29 November 2023

21-558

167-173 Pilkington Road Clause 23 Further Information

Figure 1 Apirana Road Traffic 2022

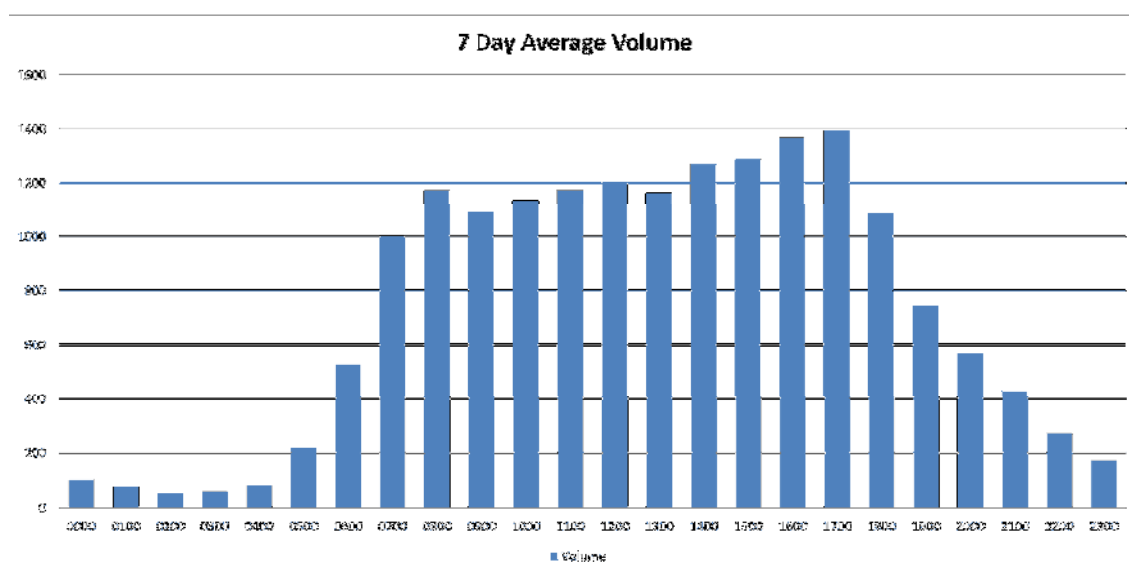
Please provide an assessment to determine whether the static traffic volumes on adjoining roads are a result of the local network operating at capacity as opposed to being a result of flattened traffic demand?

I have obtained the traffic count data from Auckland Transport and attached the hourly plot for the 2022 data below.

As can be seen the Apirana Road count has a distinct evening peak hour which indicates there is spare capacity at other times of the day. The lack of any noticeable annual growth shown in the

ITA cannot therefore be the result of the road or adjacent intersections being at capacity throughout the day. This is reinforced by the fact there are queues at times in the two peak periods and not throughout the day.

Figure 2 Cycle Crash 2022 (shown in red)

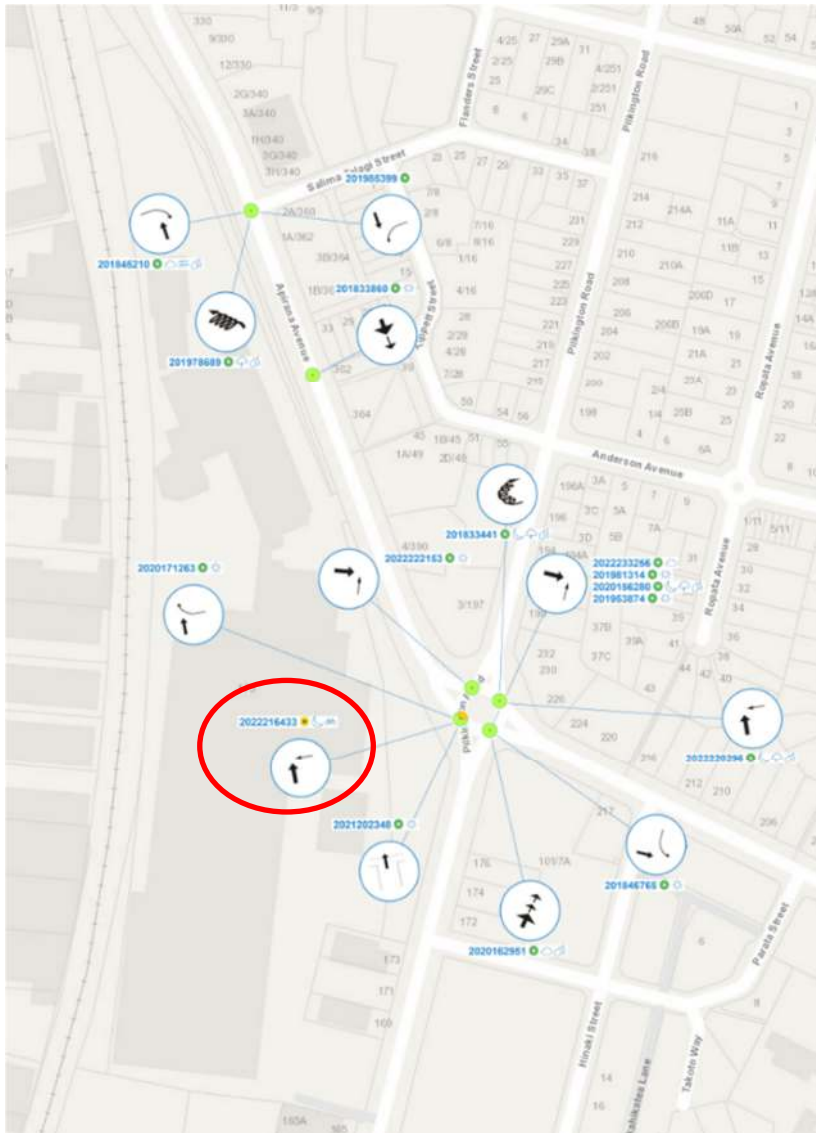
Please advise whether any of the crashes involved pedestrians or cyclists.

None of the reported crashes involved a pedestrian. One reported crash at the Pilkington Road roundabout involved a cyclist as shown in red below.

The crash occurred in February 2022 at 5:45 am during darkness. A car entering the Pilkington Road roundabout from the south failed to give way to a 14 year old cyclist already on the roundabout despite the cyclist having lights and wearing a high visibility top.

Figure 3 Census Journey to Work from Point England and Glen Innes 2018

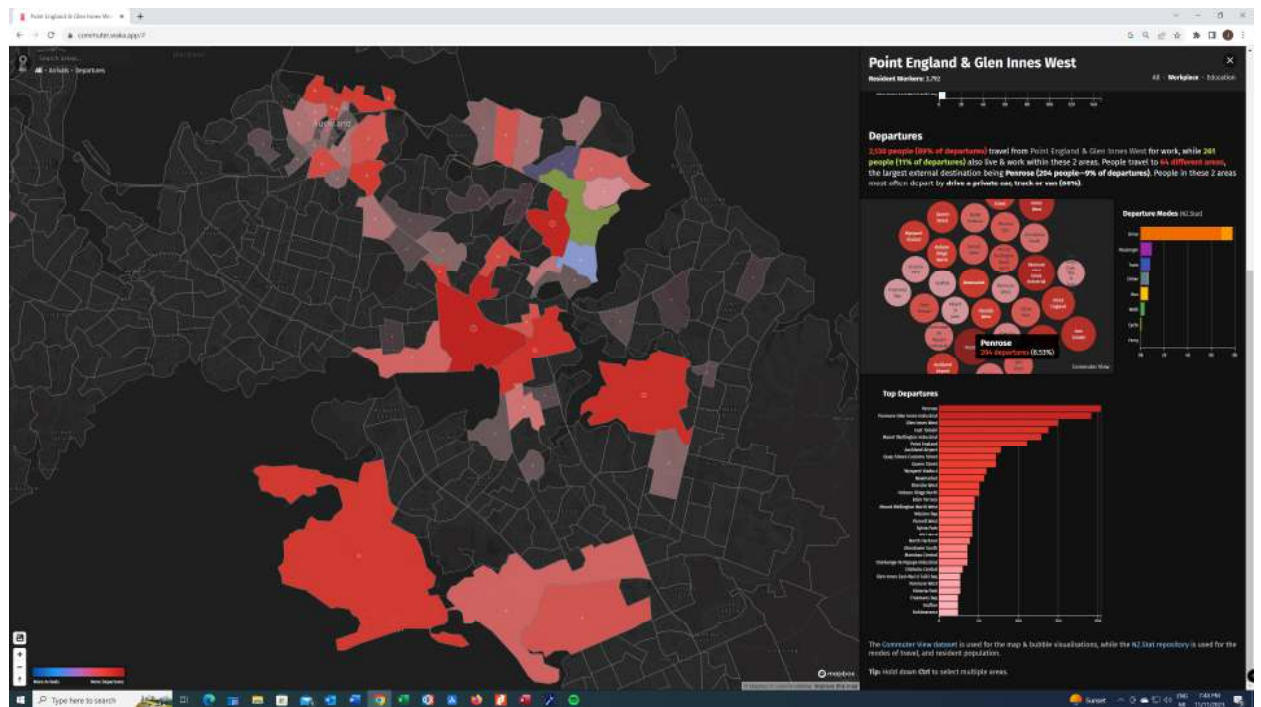
What is the basis of the trip distribution assumptions used?

E) The distribution of traffic was developed from the observed counts but modified to reflect the location of likely work destinations. The eight development areas scheduled in the indicative development plan were assumed as internal zones and six external zones were assumed as follows: Merton Rd, Apirana Ave North, Line Road, Pilkington Road North, Tripoli Road, and Pilkington Road south. These external links were then assigned a share of origins and destinations to reflect work and non work trips that might occur based on a broad catchment.

The largest share of morning peak trips were assigned to the south to reflect the strong influence of south Auckland employment zones on travel from the neighbouring two statistical areas of Point England and Glen Innes.

Figure 5 AT Links to Glen Innes

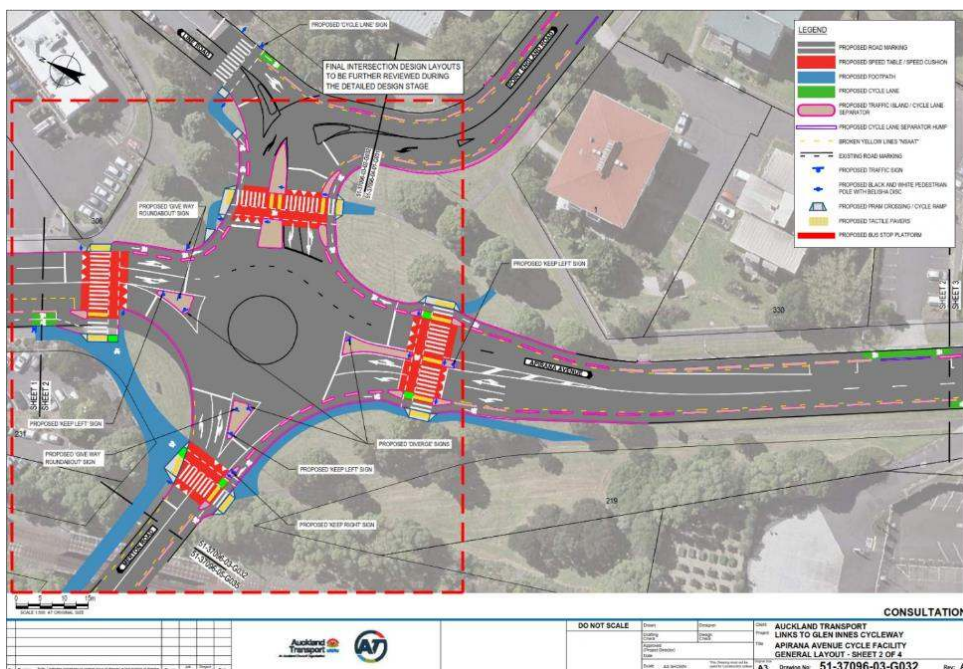
Section 6.4 & 6.5 of ITA
 Please undertake a sensitivity test for the Merton Road roundabout to reflect the reduced capacity shown in figure 10 of the ITA?

The reduction in capacity proposed by AT consists of the following changes at the Merton Road roundabout:

- Removal of one departure lane on Merton Road,
- Removal of one departure lane on Apirana Road north of the roundabout;
- Removing through traffic from the right hand approach lane on Line Road;
- Removing through traffic from the left hand approach lane on Apirana Road south of the roundabout.
- The installation of zebra crossings on all four approaches.

Figure 8 Lower Bound of Footpath Level of Service

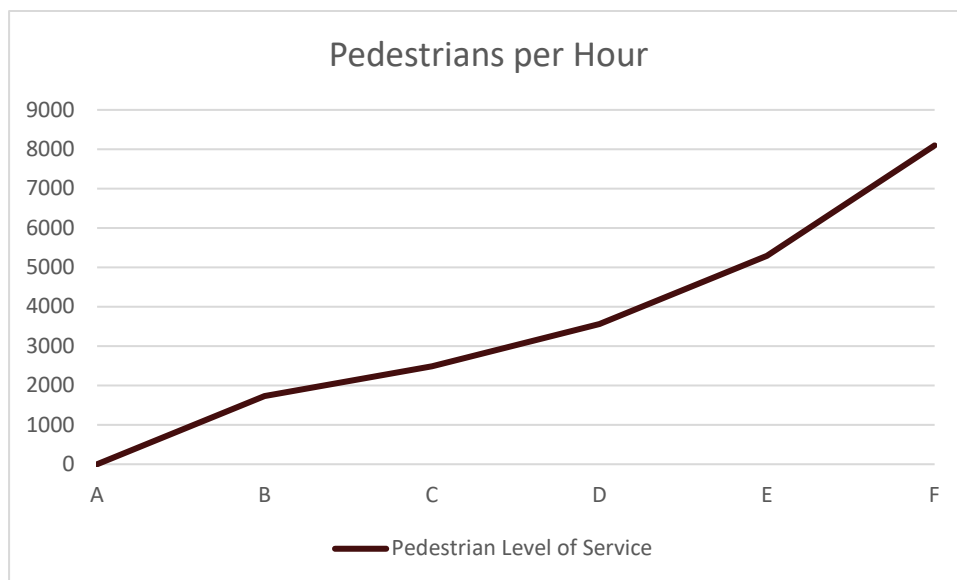
Please provide an assessment of the level of service to be provided for pedestrians. This should focus on the connections across Apirana Avenue to other likely destinations and take into account AT's proposed zebra crossings at the Merton Road/Apirana Avenue roundabout.

This means that provided the footpath carries fewer than 1728 people per hour then it will operate at level of service A and the footpath will not operate at level of service F unless the demand increases to 8100 pedestrians per hour. Based on the development enabled by the plan change, it is expected that a level of service A will be maintained. We can conclude the footpath capacity is not an issue for the plan change.
